Access Audit Site Report

Meridian State Park

Accessibility Evaluation

**TEXAS PARKS AND WILDLIFE DEPARTMENT
MERIDIAN STATE PARK**

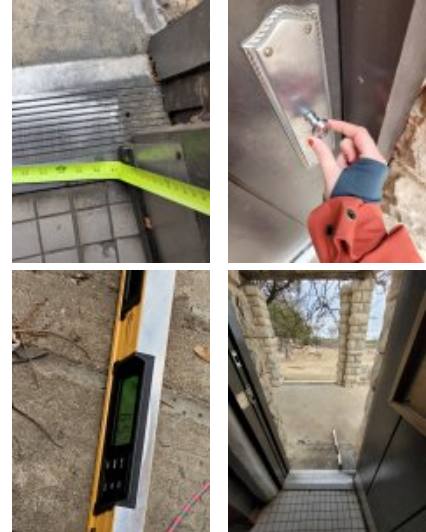
Finding Number	Area Description	Lat/Long	Finding	As Built	Recommendation	Citation	Photos	Figure
144	Lakeside Campground: Lakeside - Men's Restroom	[31.8888284 , -97.6997815]	The bench is not deep enough or long enough or is missing. Benches shall be provided having seats that are 42 inches long minimum and 20 inches deep minimum and 24 inches deep maximum. The bench shall provide for back support or shall be affixed to a wall. Back support shall be 42 inches (1065 mm) long minimum and shall extend from a point 2 inches (51 mm) maximum above the seat surface to a point 18 inches (455 mm) minimum above the seat surface. Back support shall be 2½ inches (64 mm) maximum from the rear edge of the seat measured horizontally. The top of the bench seat surface shall be 17 inches (430 mm) minimum and 19 inches (485 mm) maximum above the finish floor or ground.	Men's restroom - bench seat depth 17"	Replace bench in dressing area with one having a seat depth of 20" to 24" deep, 42" long, affixed to the wall or having a back and mounted 17" to 19" aff	2012 TAS Section: 903.4, 903.2, 903.3, 903.5 2010 ADAS Section: 903.4, 903.2, 903.3, 903.5

145	Lakeside Campground: Lakeside - Men's Restroom	[31.8888148 , -97.699768]	The shower seat does not have a compliant space between it and the wall. The folding seat must be mounted 17-19 inches above the floor, and have a maximum space of 1-1/2 inches between the edge of the seat and the side wall and 2-1/2 inches maximum to the seat wall.	Men's restroom - shower seat installed 2.5" from side wall	Remount shower seat to the correct location and height in the shower	2015 ABAAS Section: 610.3.2 2012 TAS Section: 610.3.2 2010 ADAS Section: 610.3.2

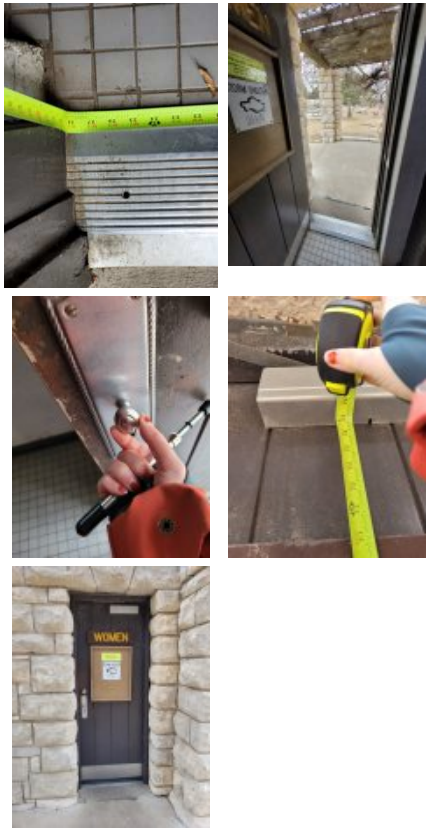
Finding Number	Area Description	Lat/Long	Finding	As Built	Recommendation	Citation	Photos	Figure
154	Lakeside Campground: Lakeside - Women's Restroom	[31.8888034 , -97.699786 8]	The restroom sign does not comply with one or more applicable requirements for the location, height, and properties of the sign.	Women's restroom - signage is non compliant, lacks symbol of accessibility	Acquire and mount signage, including Braille, raised lettering and access symbol mounted on wall, latch side of door, 48" to baseline of lowest character and 60" to baseline of highest character	2015 ABAAS Section: F216.2, 703.1, 703.2, 703.5, 703.6 2012 TAS Section: 216.2, 703.1, 703.2, 703.5, 703.6 2010 ADAS Section: 216.2, 703.1, 703.2, 703.5, 703.6		
155	Lakeside Campground: Lakeside - Women's Restroom	[31.8887851 , -97.699770 7]	Knee and toe clearance has not been provided at the sink. The knee clearance shall be 11 inches deep minimum at 9 inches above the finish floor or ground, and 8 inches deep minimum at 27 inches above the finish floor or ground. The toe clearance is the space under the sink between the finish floor or ground and 9 inches above the finish floor 30 inches wide minimum.	Women's restroom - sink lacks knee and toe clearance	Remove under sink barrier to provide knee and toe clearances under sinks and insulate exposed pipes	2012 TAS Section: 606.2 2010 ADAS Section: 606.2

156	Lakeside Campground: Lakeside - Women's Restroom	[31.8887943 , -97.699786 8]	The dimensions of the toilet stall do not comply. Wheelchair accessible compartments shall be 60 inches wide and 59 inches deep minimum for floor mounted water closets measured perpendicular to the rear wall. Door shall not swing into the minimum clear floor space required for the toilet.	Women's restroom - 56" depth x 61" width	Widen accessible stalls to min. 60" clear width, 59" depth	2015 ABAAS Section: 604.8.1.1 2012 TAS Section: 604.3.2 2010 ADAS Section: 604.3.2

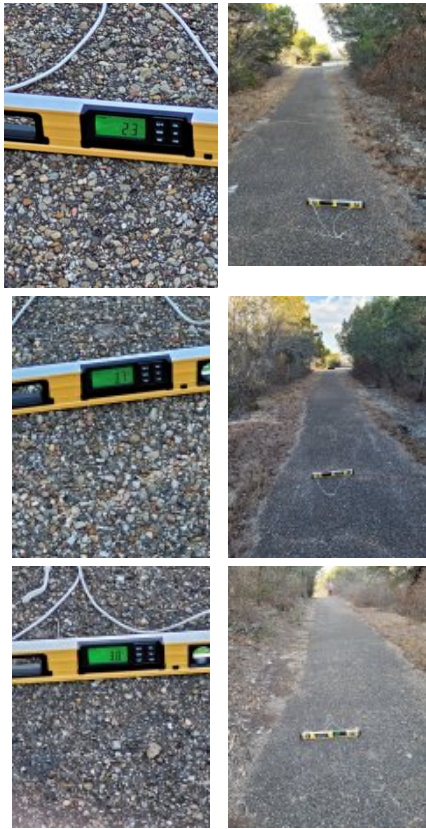
Finding Number	Area Description	Lat/Long	Finding	As Built	Recommendation	Citation	Photos	Figure
167	Lakeside Campground: Lakeside - Boat Launch	[31.8887929 , -97.700213]	The operable part is positioned too high for either a side or front approach. Where a clear floor or ground space allows a parallel approach to an element and the side reach is unobstructed, the high side reach shall be 48 inches maximum and the low side reach shall be 15 inches minimum above the finish floor or ground. Where a forward reach is unobstructed, the high forward reach shall be 48 inches maximum and the low forward reach shall be 15 inches minimum above the finish floor or ground.	Lakeside day use - canoe rental hardware on storage lacks handles	Remount operable parts to be in reach range of 15" min to 48" max	2015 ABAAS Section: 308.1 2012 TAS Section: 308.1 2010 ADAS Section: 308.1		
168	Lakeside Campground: Lakeside - Fishing Pier	[31.8886576 , -97.700350 1]	The required edge protection is not provided. Where compliant railings, guards, or handrails are provided, edge protection shall also be provided. Curbs or barriers shall extend 2 inches minimum above the surface of the fishing pier or platform or The ground or deck surface shall extend 12 inches minimum beyond the inside face of the railing. Toe clearance shall be provided and shall be 30 inches wide minimum and 9 inches minimum above the ground or deck surface beyond the railing.	Lacks curb or barrier along edge, railing installed 5" above ground	Provide 2" high curb or 12" extended surface beyond railing for edge protection.	2015 ABAAS Section: 1005.3.1, 1005.3.2 2010 ADAS Section: 1005.3.1, 1005.3.2
